NRL/MR/7441--94-7097

Digital Mapping, Charting, and Geodesy Analysis Program Technical Review: Digital Nautical Chart Product 1

December 9, 1994

TECHNICAL REVIEW: DIGITAL NAUTICAL CHART PRODUCT 1

Fig. 1 — Compass rose from DNC chart 12245

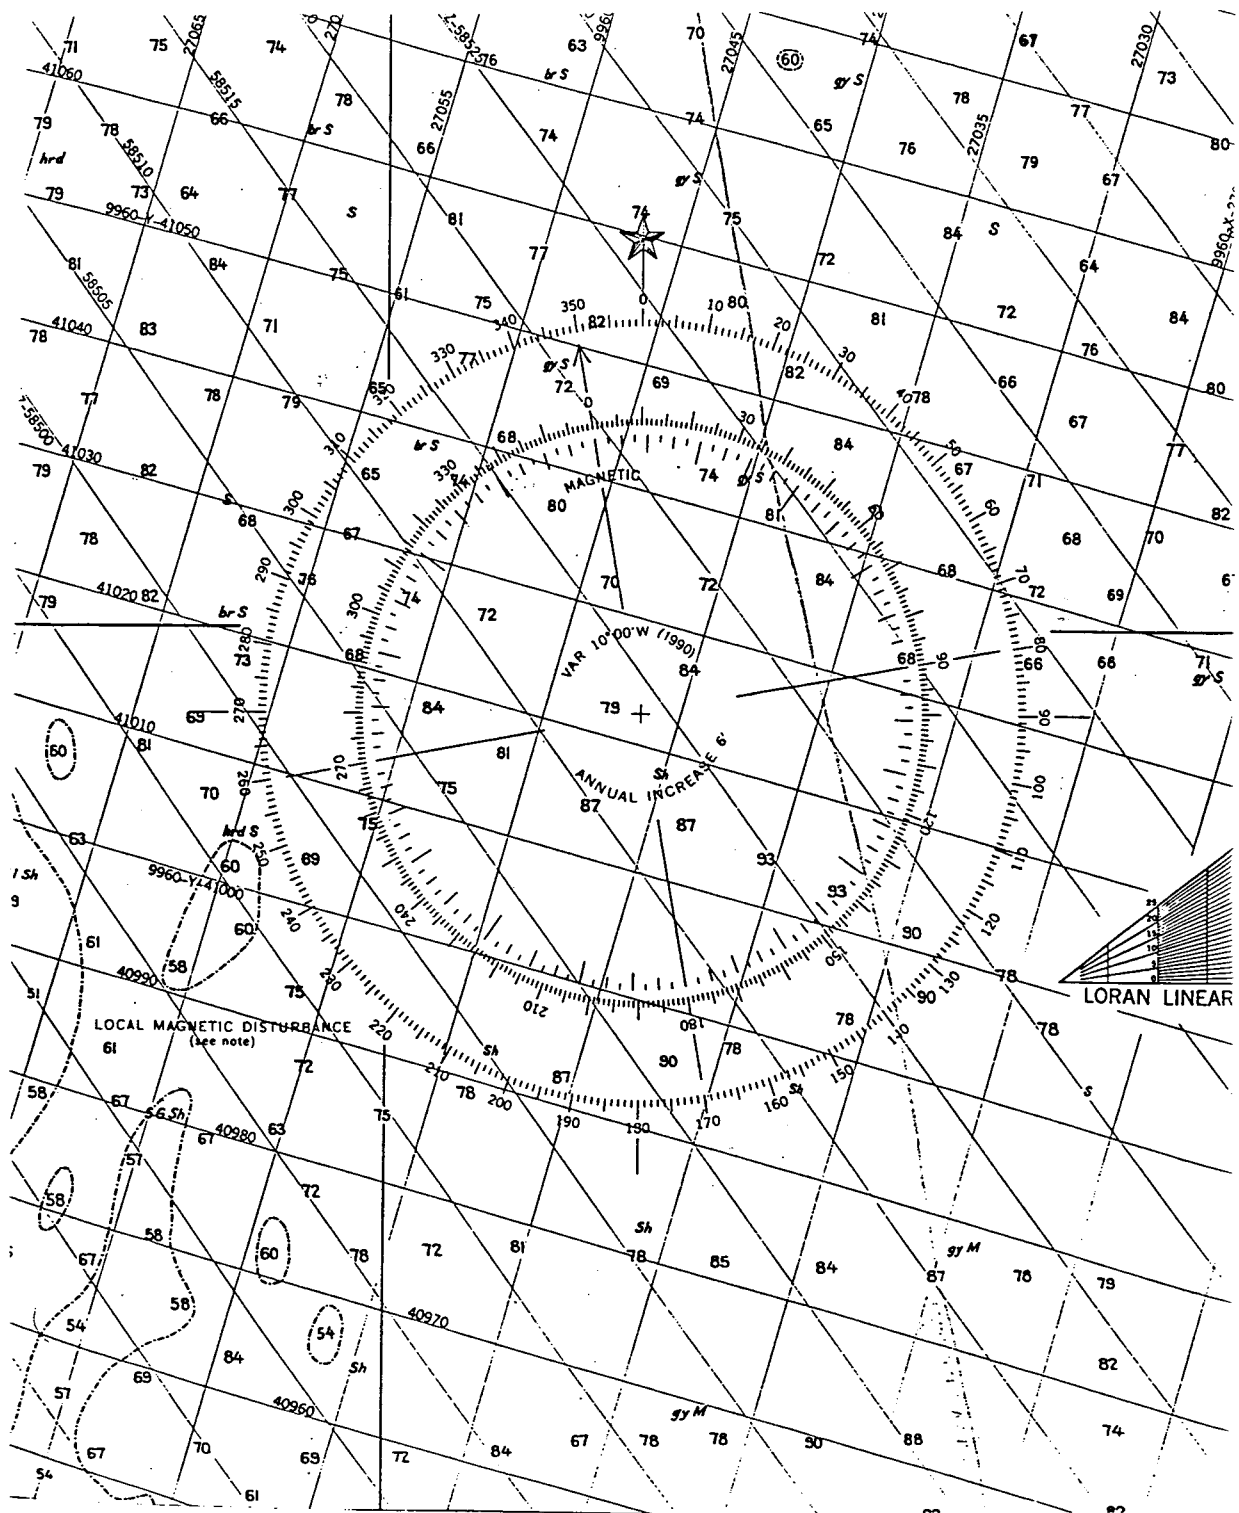
Compass roses (Fig. 1) are used to give information on magnetic variation for the areas in which they are placed. They tell the measure and direction of the variation, the year in which this measurement was made, and the expected annual increase in the variation. This data could easily be represented in the DNC with the creation of a new point feature (i.e., "Magnetic Variation") with three attributes containing the data mentioned above.

Fig. 5 — Labeling of DNC features

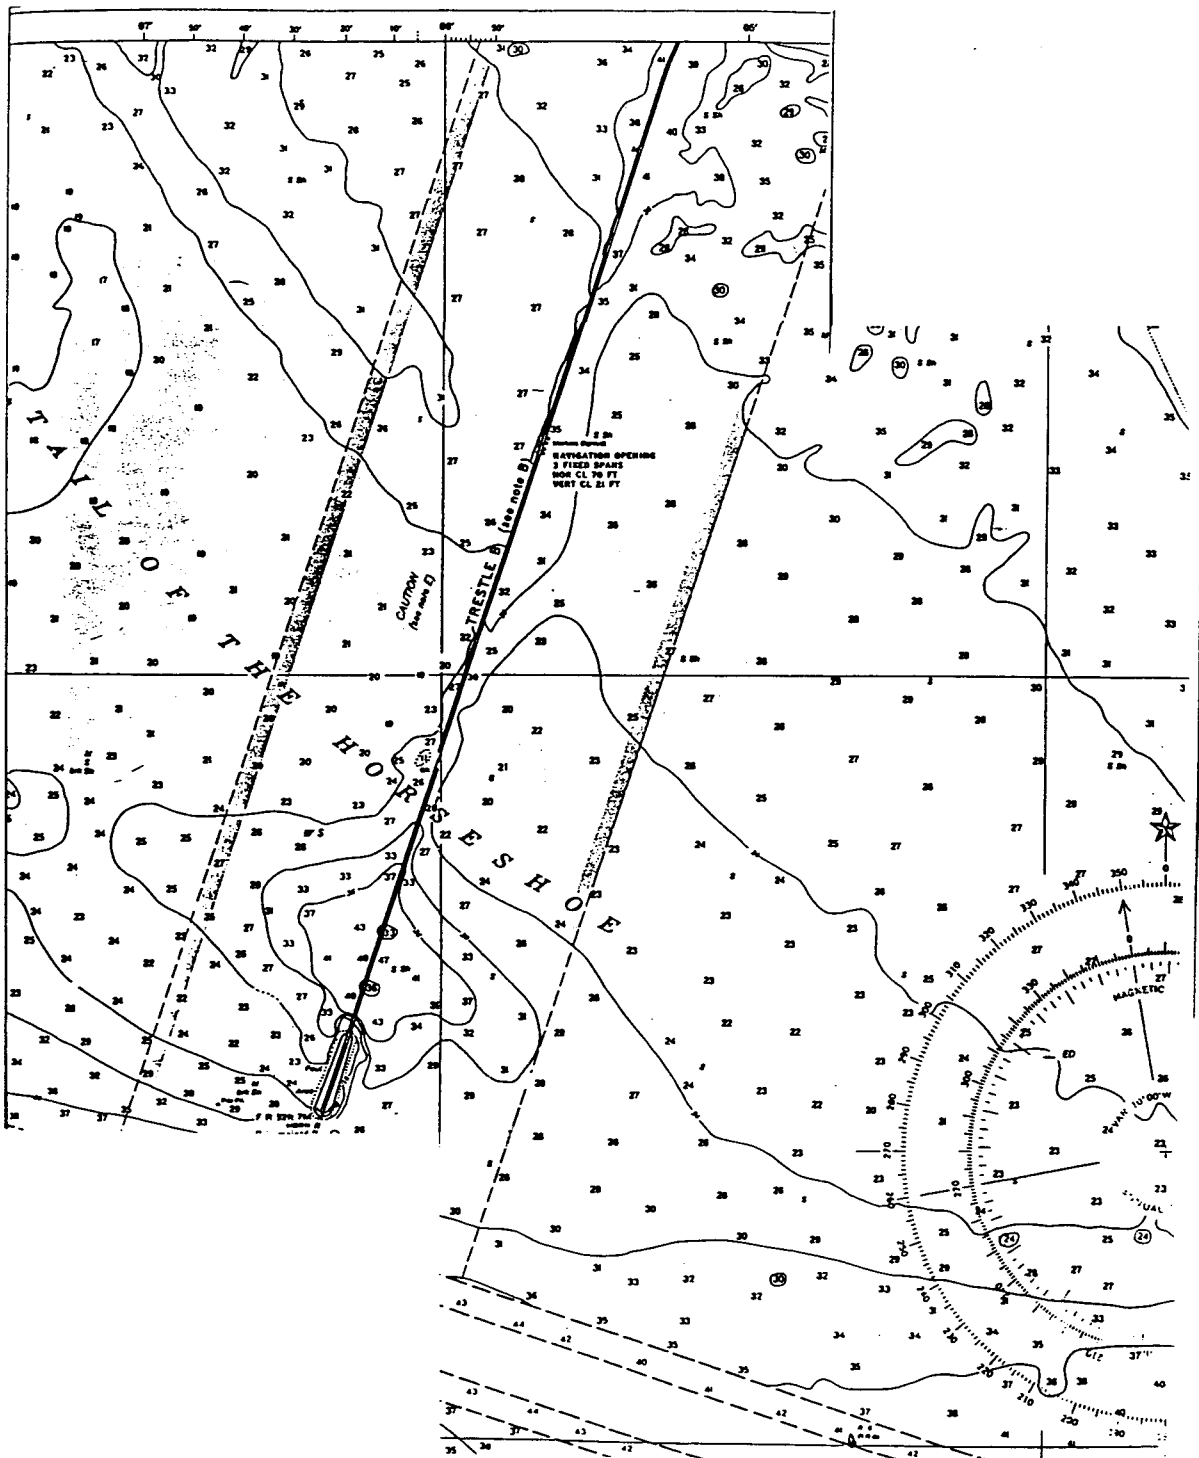
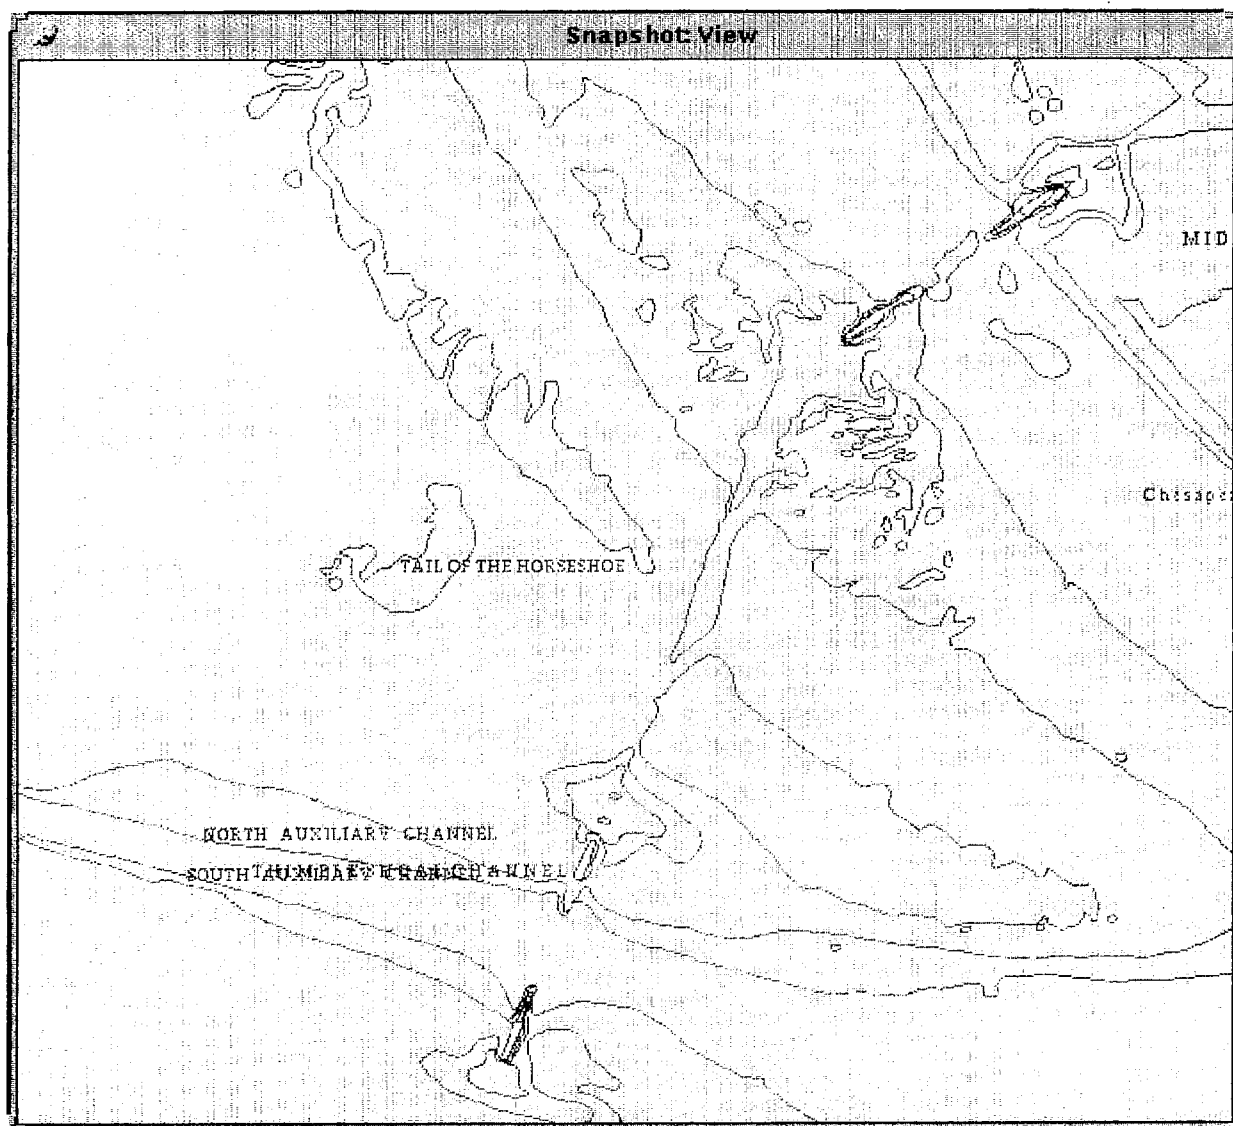
As mentioned in previous DMAP reviews of the DNC, text would be more descriptive if it followed the feature that it describes. Figures 4 and 5 represent labeling on the original paper chart

and in the DNC, respectively. As can be seen by comparing the two figures, the label in Fig. 4 follows the feature, but in Fig. 5 the label is almost perpendicular to the feature. This could cause obvious confusion.

Fig. 6 — Interchart inconsistencies due to different DNC chart scales in the Harbor library

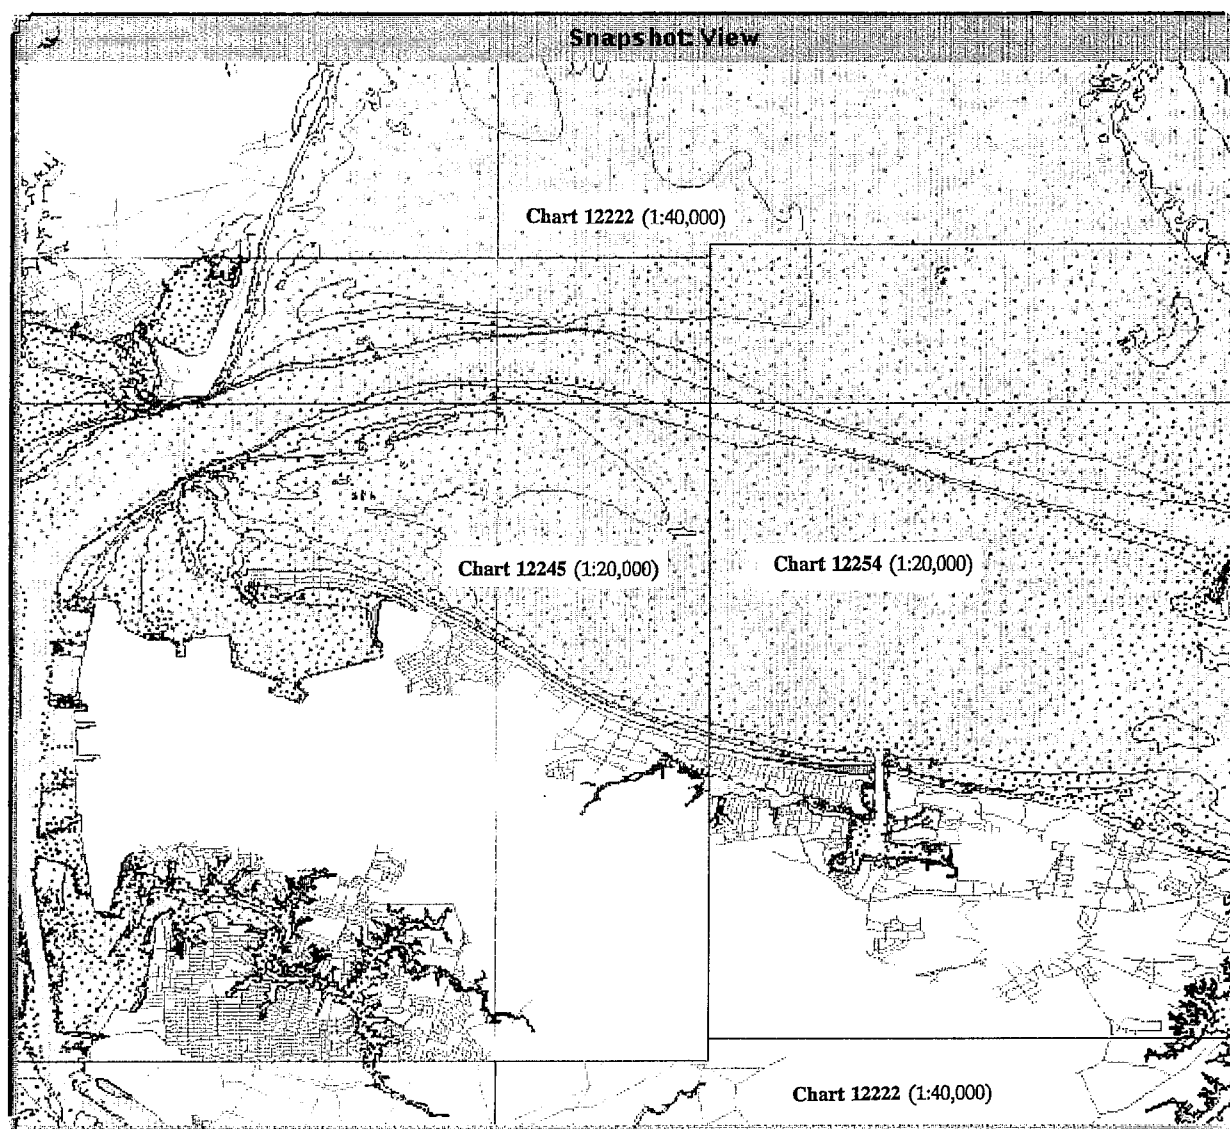
In several instances, where charts of different scales in the same library meet, an unexplained change in the data occurs. This change is especially true in the Harbor library since the library consists of three different charts with two different scales. As an example, Built-up Areas on chart 12222 (1:40,000) abruptly ends where chart 12245 (1:20,000) begins (Fig. 6). Chart 12245 has no Built-up Areas, but instead shows a dense network of streets. A similar situation occurs in Fig. 6 with Soundings in the Hydrography layer. There is a noticeable line across Chesapeake Bay where the low density of soundings on chart 12222 suddenly ends and the higher sounding density on charts 12245 and 12254 begins (both 1:20,000).

Fig. 7 — Depth contour areas in DNC Harbor library

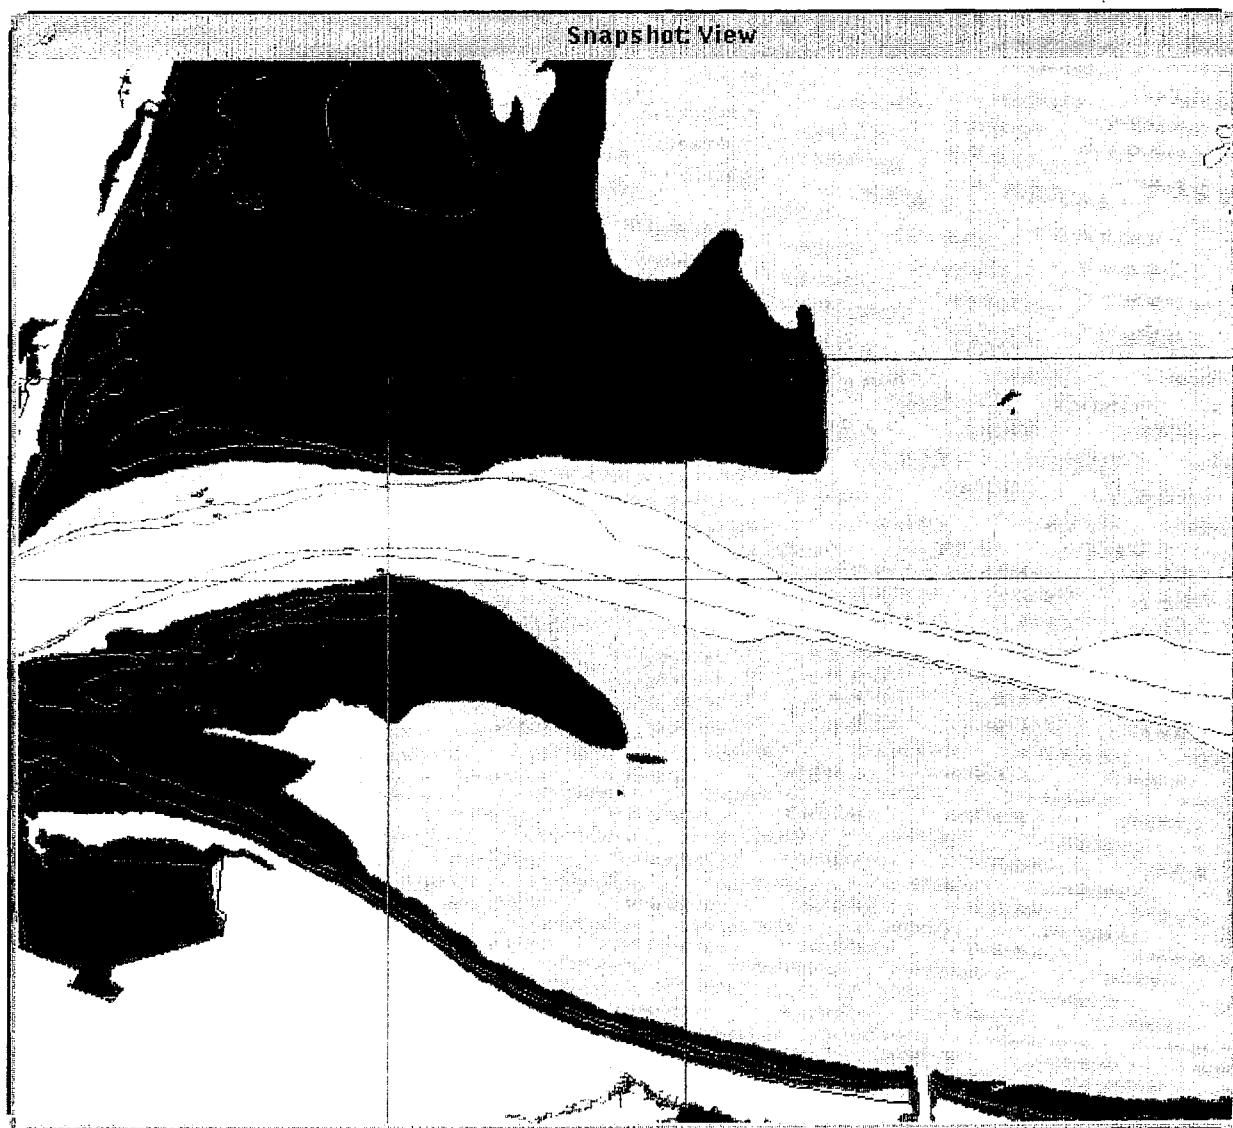
In the Harbor library, the 24-ft Depth Curve line is missing. The depth curve interval is 6 ft, but for some reason the 24-ft line is missing from paper charts 12222 and 12254. It is contained on chart 12245. To compensate for this, the 24-ft curve has mostly been removed from the digitized version of chart 12254 except for closed 24-ft contours. Comparison of Figs. 5 and 6 demonstrates this problem. Note that the DNC does not include text for contours. A spatial query would be required to obtain the contour value.

A more significant problem is where the Depth Curve areas of DNC Tiles 5 and 6 meet south of Willoughby Bank. Here a small portion of a larger Depth Curve area is contained on Tile 5 with the rest of the area on Tile 6 (Fig. 7). Both portions are entered into the DNC database with different Contour Value High attributes, causing them to graphically appear as two separate Depth Curve areas instead of one.

Fig. 10 — DNC data for Ocracoke Light

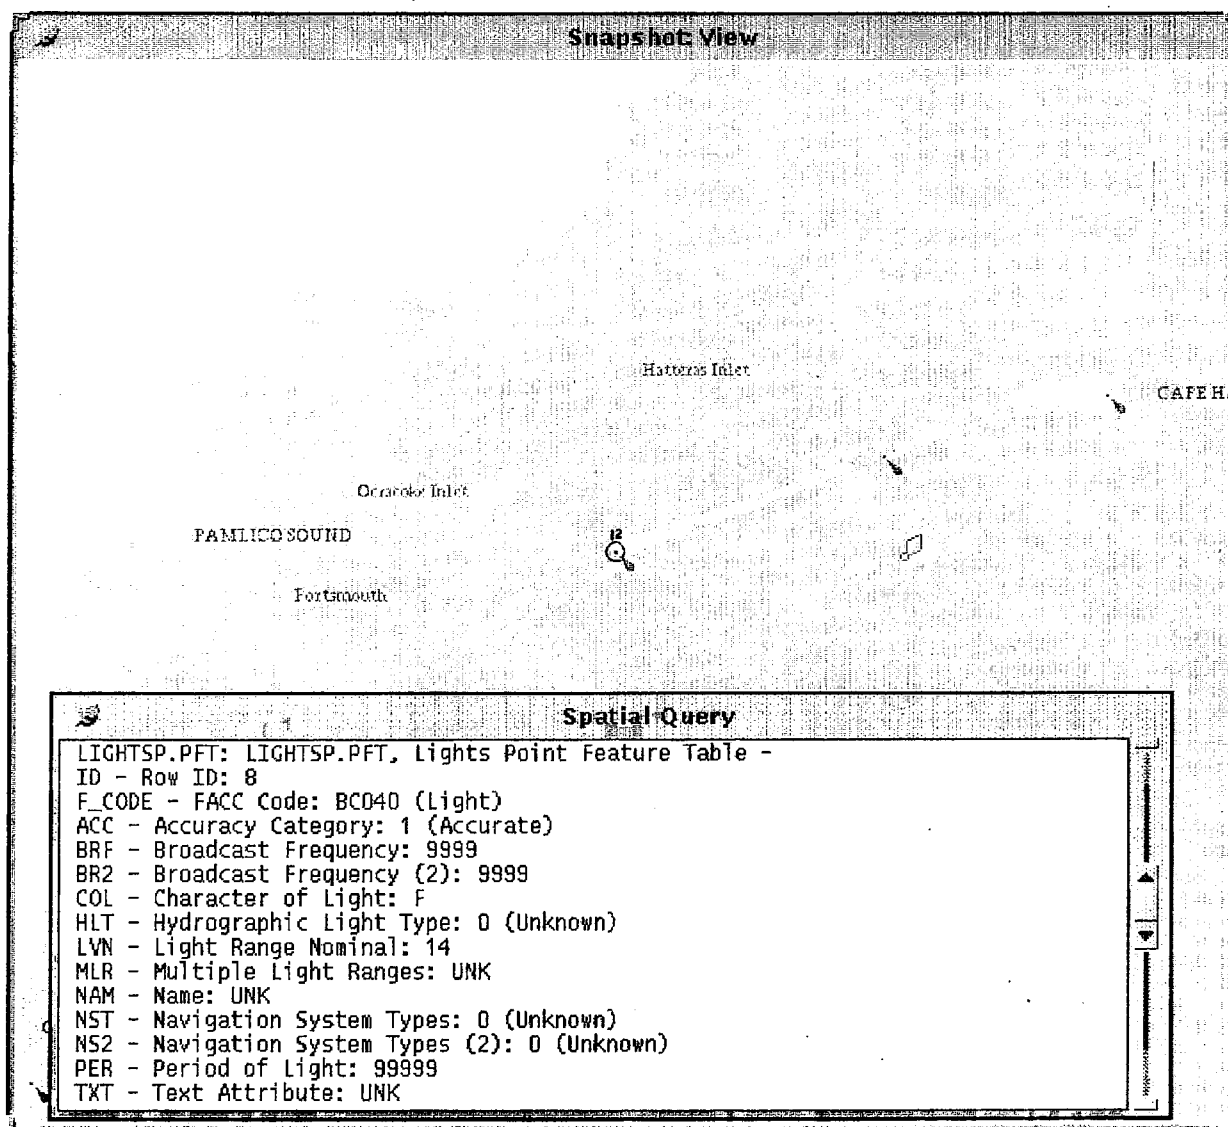
76. The attributes for Aids to Navigation should be expanded so that at a minimum they contain all of the information found in the Light List and List of Lights. This would involve adding only a few more attributes to the DNC, but the time saved for the user would be enormous (Fig. 9). Additional attributes would describe the fixed structures upon which aids are mounted, any emergency lights, any seasonal remarks (some buoys are replaced or removed during winter), any private aid identification, and the year established, moved or rebuilt. This would significantly reduce the excessive entries of "Unknown" as currently done for attribute values (Fig. 10), thus making the DNC a more complete and informative database.
